SERVICE BULLETIN

APPLICABILITY: 2019-24MY Ascent
2020-24MY Outback & Legacy 2.4L

NUMBER: 09-130-25R

SUBJECT: Exhaust Manifold Flange Nut / Torque & Design Change

EX-10383

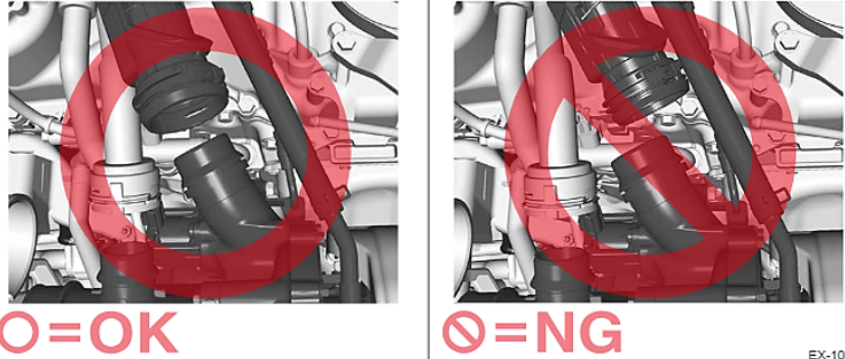
The torque procedure has been changed from a one-time torque of 65 Nm (6.6 kgf-m, 47.9 ft-lbs) to a two-step procedure with an initial torque of 55 Nm (5.6 kgf-m, 40.6 ft-lbs) then a final torque of 65 Nm (6.6 kgf-m, 47.9 ft-lbs). A section of the Service Manual is pictured below. The added service procedure (4.) has been outlined in **RED** and will be added to the applicable Service Manual in the future.

O=OK **X=NG**

EX-10326

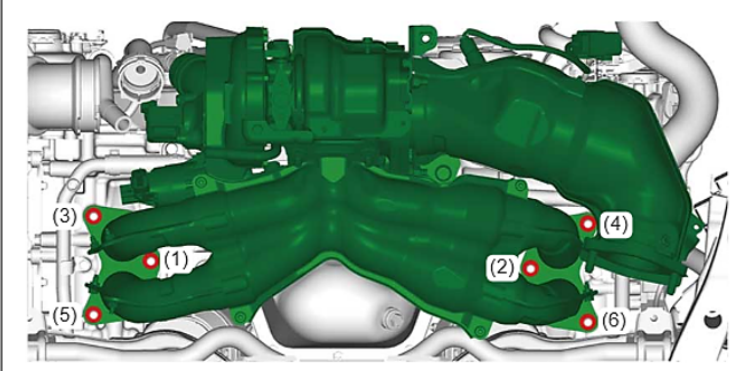
Added Step

4. Tighten the nuts in the numerical order as shown in the figure.
Tightening torque:
55 N·m (5.6 kgf-m, 40.6 ft-lb)

5. Tighten the nuts again in the numerical order as shown in the figure.
Tightening torque:
65 N·m (6.6 kgf-m, 47.9 ft-lb)
